HISTORIC PRESERVATION COMMISSION STAFF REPORT

CASE NUMBER: 31/6-89C

SITE/DISTRICT NAME: Kensington

PROPERTY ADDRESS: 10300 Fawcett St

FRONT ELEVATION

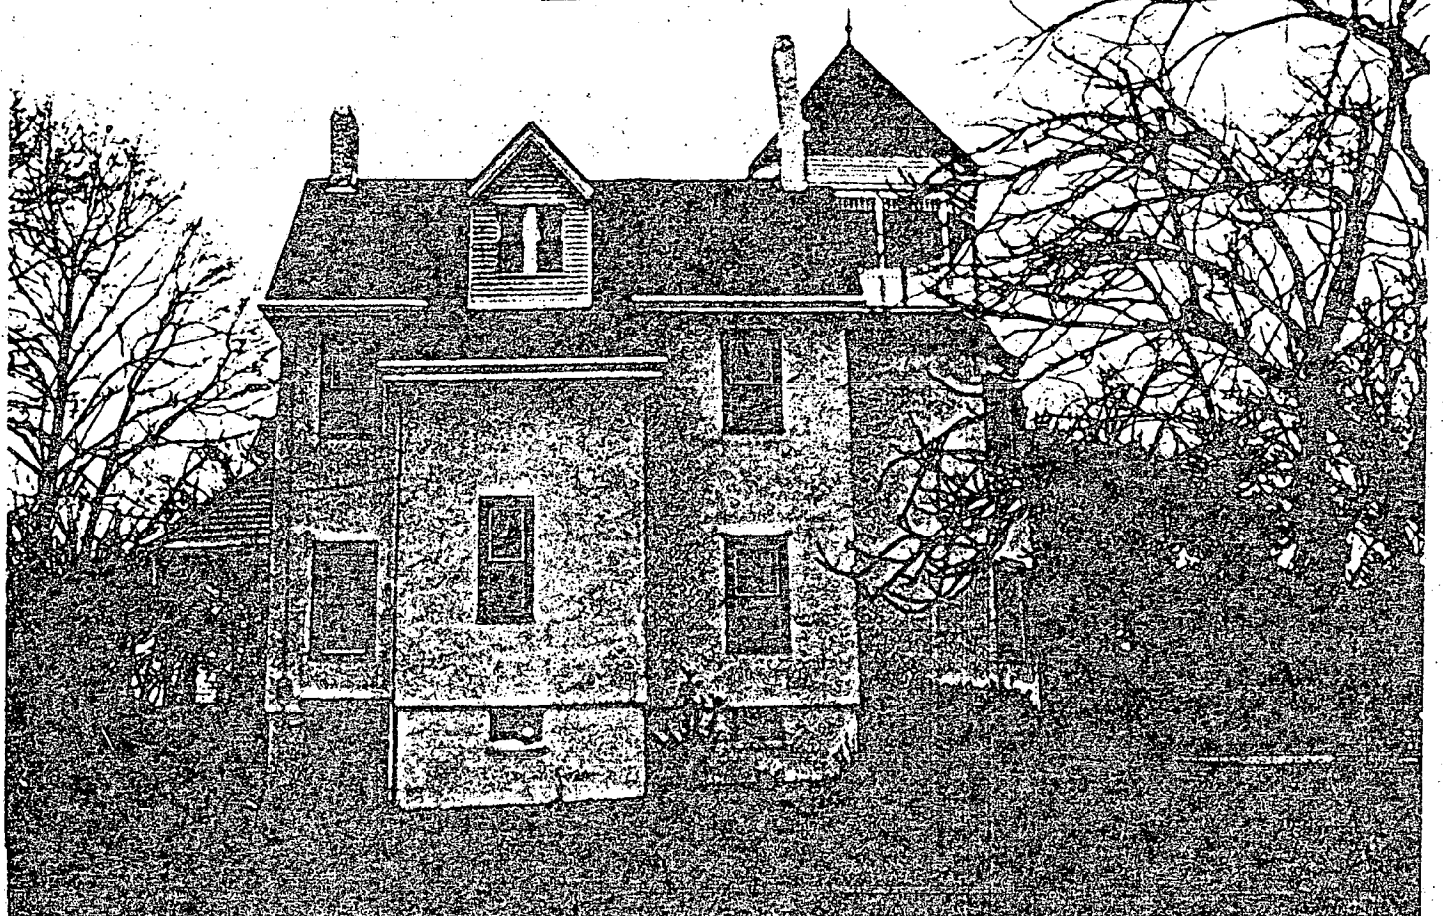
The LAC approved the application with the following exceptions: 1. The elliptical window on the front elevation in the gable. 2. The use of veneer brick on the chimneys. While the LAC did indicate some concerns about the fact that certain details were not submitted with the application, they did approve the remainder, which included landscaping, rear and north side porch addition/changes, kitchen expansion, rear deck, picket fence, replacement of chimneys, replacement of front door, addition of skylights, and addition of porch detail (front porch).

Generally, staff recommends approval of this application, with the following exceptions: 1. Staff recommends that the gable windows on the front elevation be retained and restored, as opposed to replaced. 2. That the chimney be stuccoed. 3. That the skylights proposed for the front gable not be approved, unless further information reveals them to be modest in size and profile.

1. By vote of 6 to 0 - the proposed half-round window on front of east facing gable not approved (6 to 0).

2. Skylights on east facing gable: South facing skylight approved (5 to 1). North facing skylight approved (4 to 2)

3. Addition of trim to existing front porch at top approved (5 to 1) (continued below)

With Conditions: with the exception of front gable skylights
